APPENDIX N

N2
RESPONSE TO LA-CITY LEA COMMENTS
SUNSHINE CANYON LANDFILL CITY-COUNTY JTD
FEBRUARY 27, 2008

RE: RESPONSE TO LA-CITY LEA COMMENTS
SUNSHINE CANYON LANDFILL CITY-COUNTY JTD

RE: **RESPONSE TO LA-RWQCB COMMENTS**
SUNSHINE CANYON LANDFILL CITY-COUNTY JTD

FIGURE D-D1

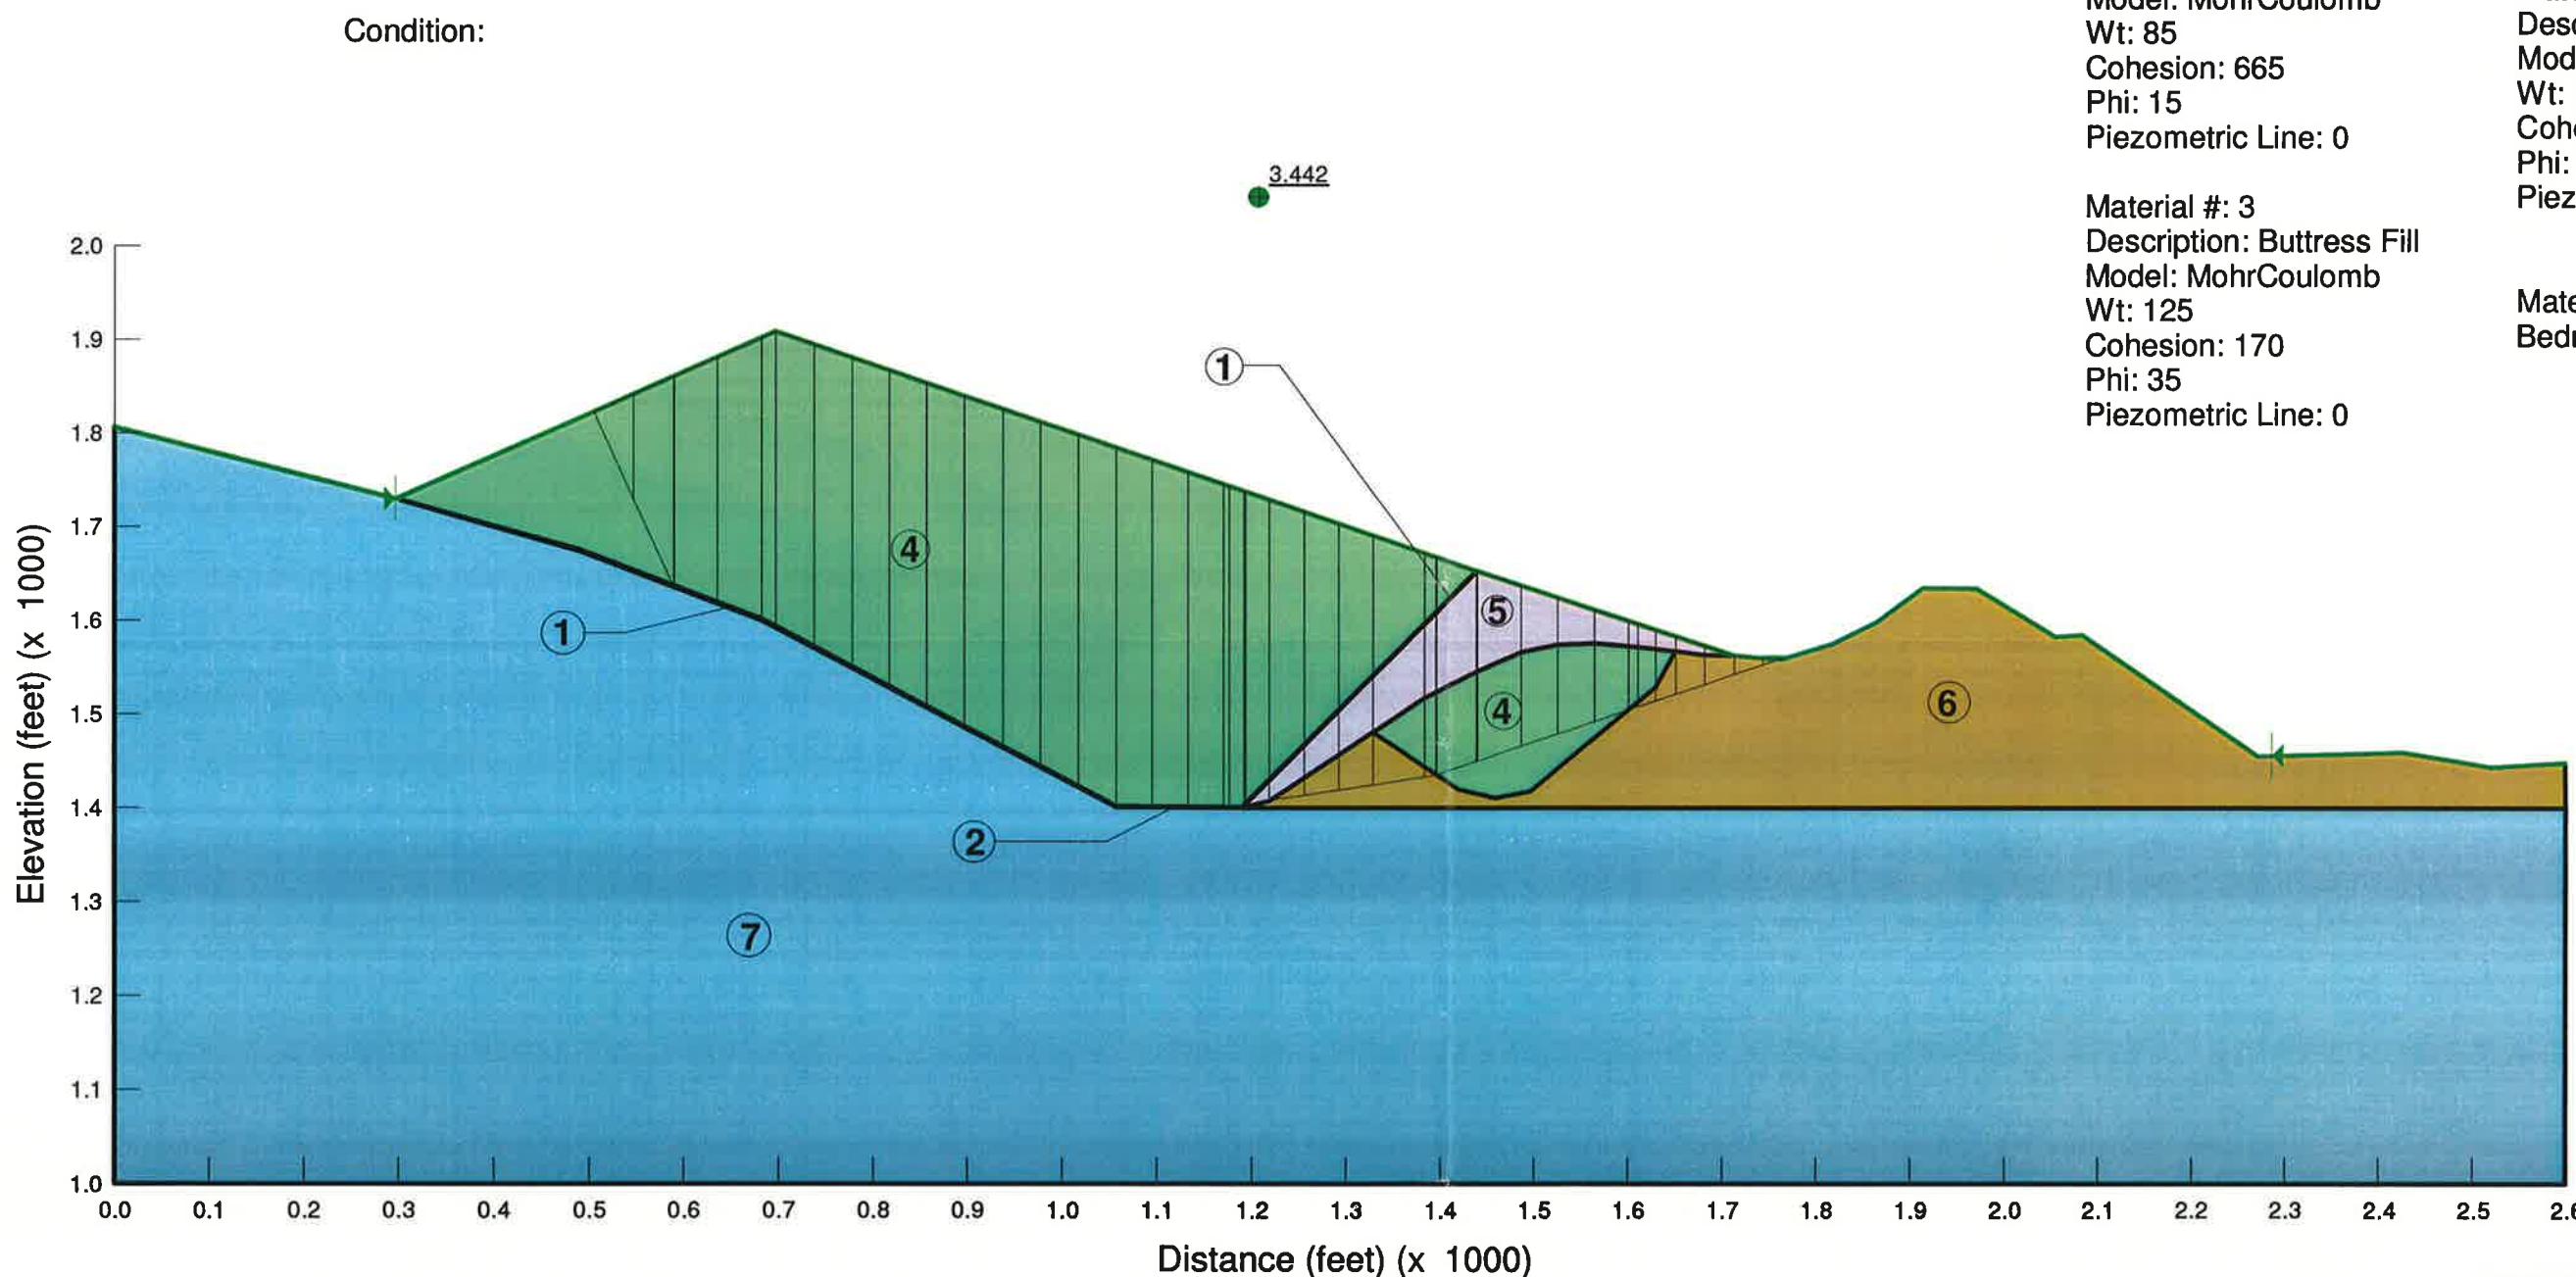
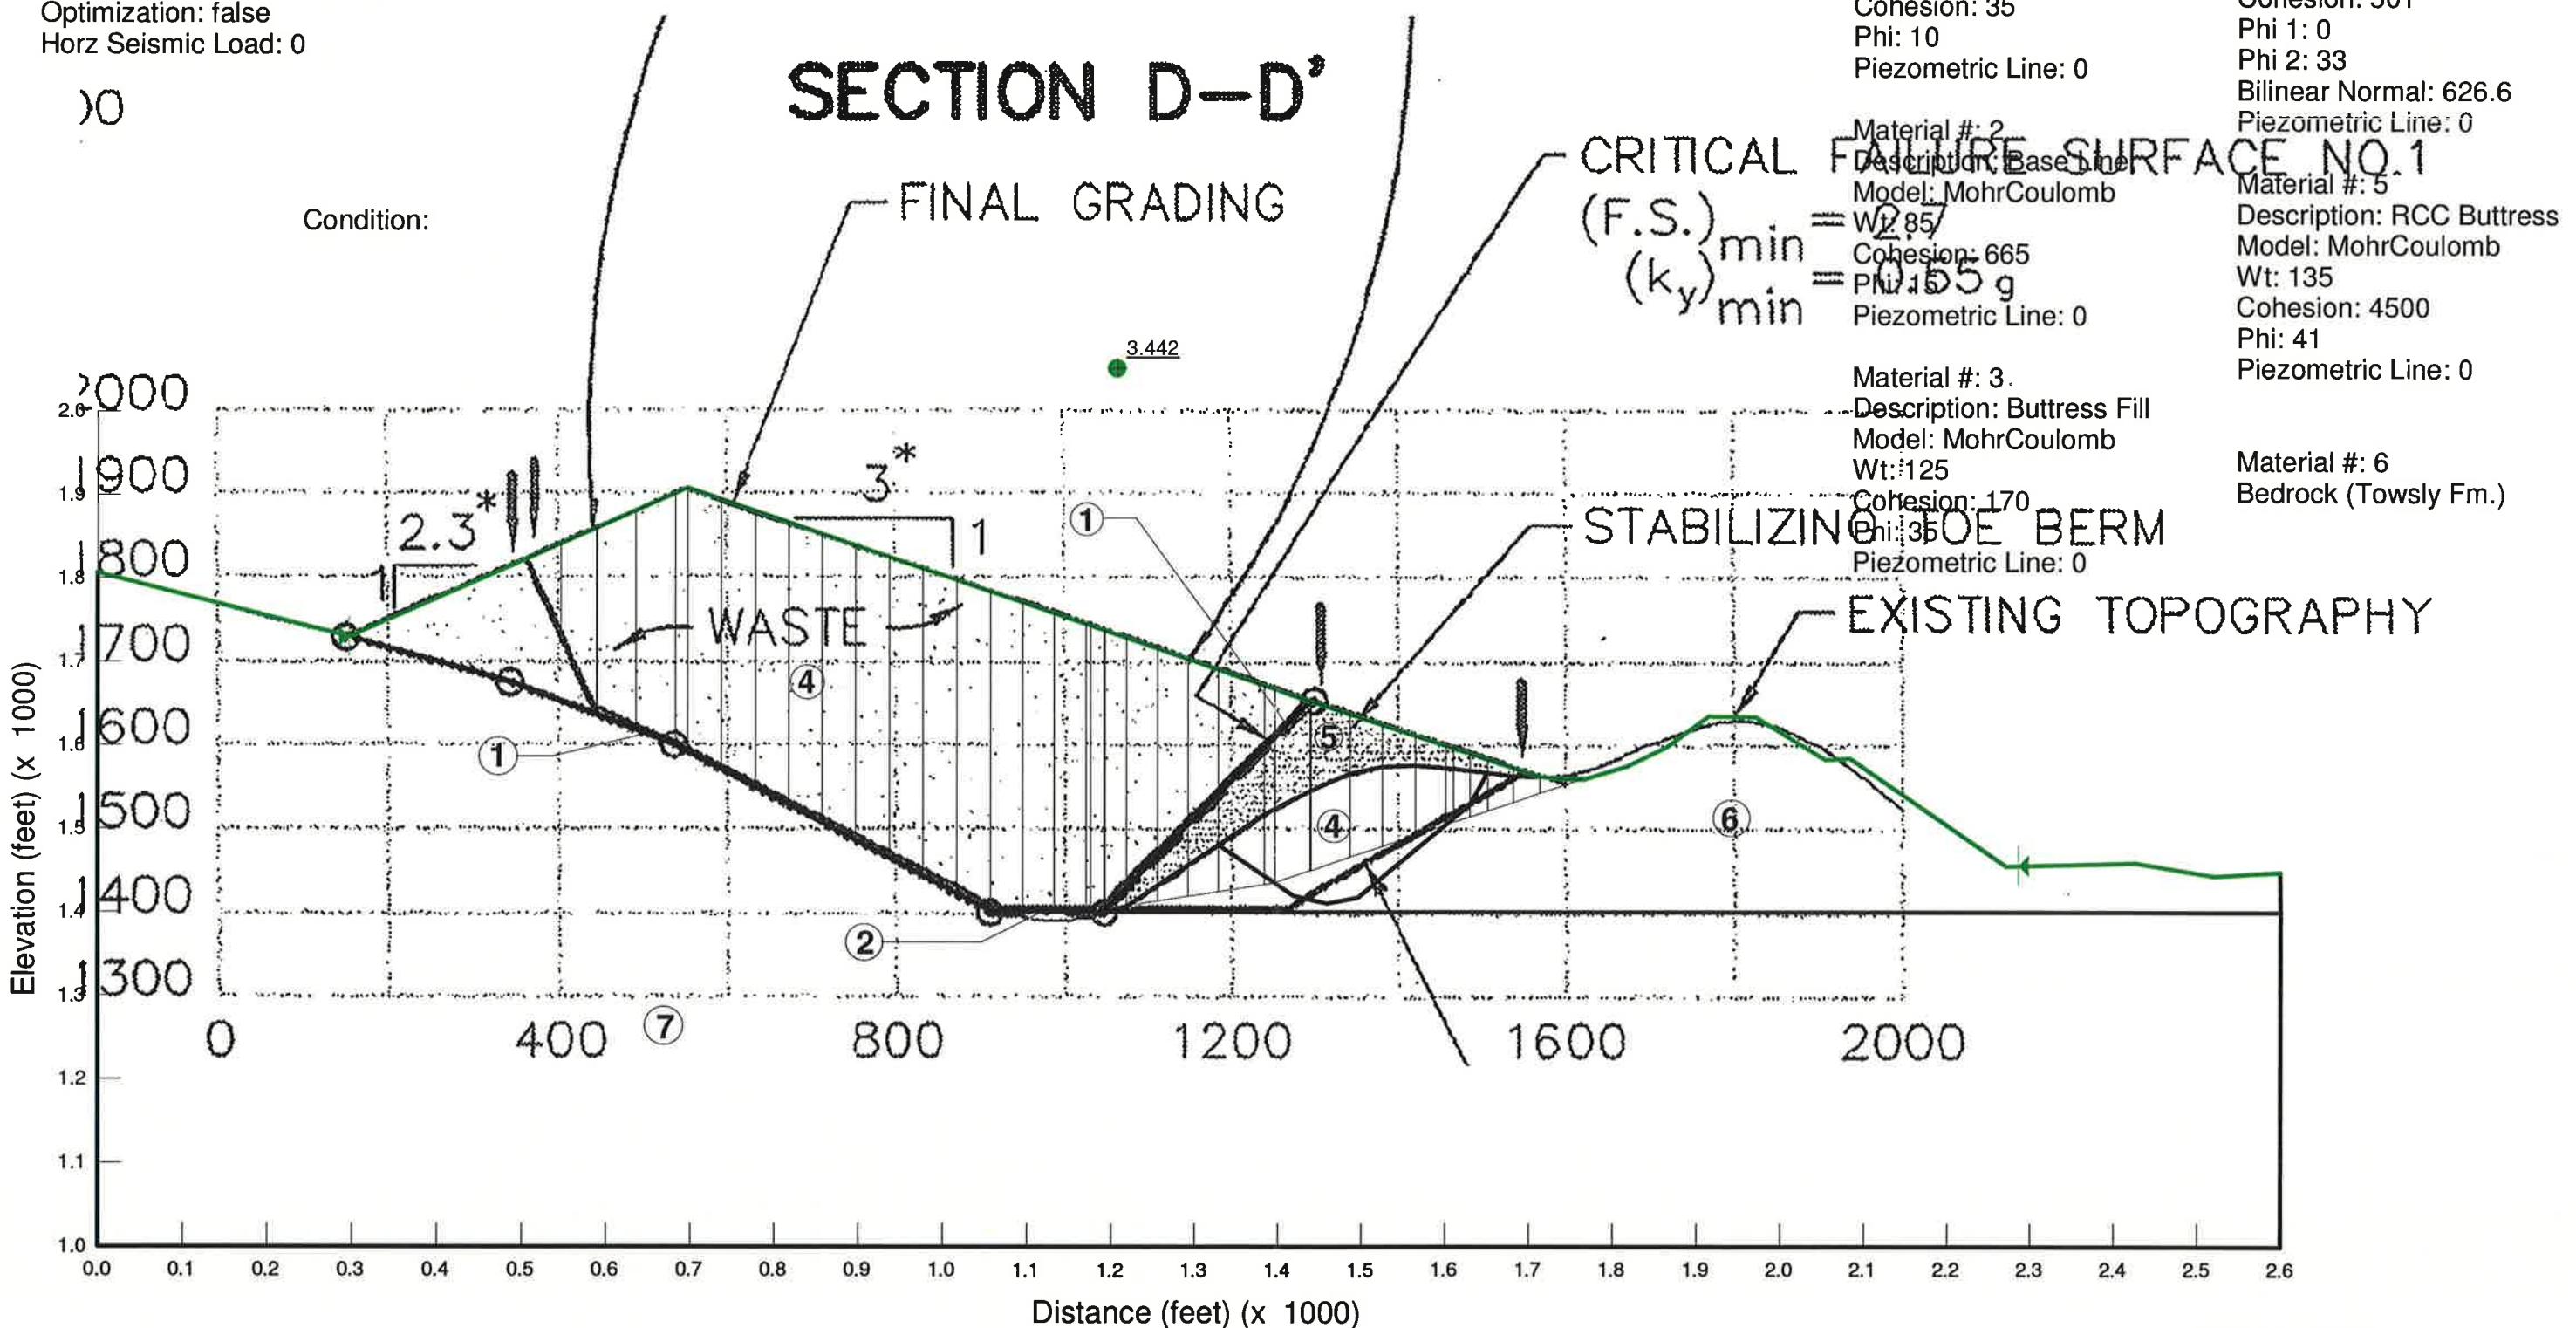
Appendix M, Excavation Slope Stability Analysis and Final Refuse Fill Slopes, Figure 7-6, and Figure 7-7, and Figure 7-8, Section C-C' and Section D-D'; The Section C-C' and Section D-D' slope stability analyses cross section have a stabilizing toe berm which abuts next to "existing topography". The "existing topography" in the area of the previous closed/inactive City Landfill.

Figure 7-7 and Figure 7-8 should show the MSW portion in the cross section depiction. Please differentiate the portions that are soil, and the portions that are MSW. Please also confirm that in the assessment of the slope stability, the modeling took into consideration of the lower density of the MSW at the toe of the proposed landfill expansion."

The newest submission (November 2007, Appendix S) does not have the same slope stability analysis as the previous submission. The current submission's analysis is not applicable to the current proposed expansion. See Figure 13 and Figure 18, and compare to Figure 1a and Figure 1b included in Appendix S (Slope Stability Analysis SCL City) for which the slope stability analysis was performed. The stability analysis was not done on the proposed final contours, and this whole section is inadequate for our analysis and incorrect as written. The current Appendix S is not applicable to the expansion.

Cross Section D-D'

The commenter correctly stated that Cross Section D-D' (Figure 7-8) passes through a portion of the existing inactive City landfill. Based on a comparison of 1987 pre-development topography with the current topography, the extent of existing waste appears to be confined to a northwest-trending canyon which is separated from the access road by bedrock ridge, outcrops of which are currently visible on the surface. As presented in the attached stability analyses for Cross Section D-D', the bedrock ridge interrupts potential failure surfaces that would pass through the existing waste (see Figures D-D1 and D-D2). The static factor of safety for such a potential failure surface is 3.44, and the pseudo-static yield acceleration is greater than 0.67g; note that due to the high value of the actual yield acceleration, the stability analysis software was unable to converge on a solution for seismic coefficients greater than 0.67g (see Figure D-D3).

Recall that in Figure 7-8, the analysis passing through rock at the toe of Cross Section D-D' was the critical analysis, with a static factor of safety of 2.2 and a pseudo-static yield acceleration of 0.28g. Since the results of this analysis were not able to be recreated (and, indeed, the reanalysis proved to be much less critical), the potential liner failure mode was also reanalyzed for Cross Section D-D'. Attached Figures D-D3 to D-D6 present the results of the reanalysis of the liner failure mode; the static factor of safety is 1.97, and the pseudo-static yield acceleration is greater than 0.39g. As above, the stability analysis software was unable to converge on a solution for seismic coefficients

greater than 0.39g, so the actual yield acceleration is greater than this value (see Figure D-D6).

The maximum seismically-induced permanent displacement presented in the 2002 JTD for Cross Section D-D' of about 18 inches was based on a yield acceleration of 0.22g (see Table 7-6). Since the lowest yield acceleration for the reanalyses of Cross Section D-D' presented herein is greater than 0.39g, the estimate of 18 inches of seismically-induced permanent displacement from the 2002 JTD analyses is conservative.
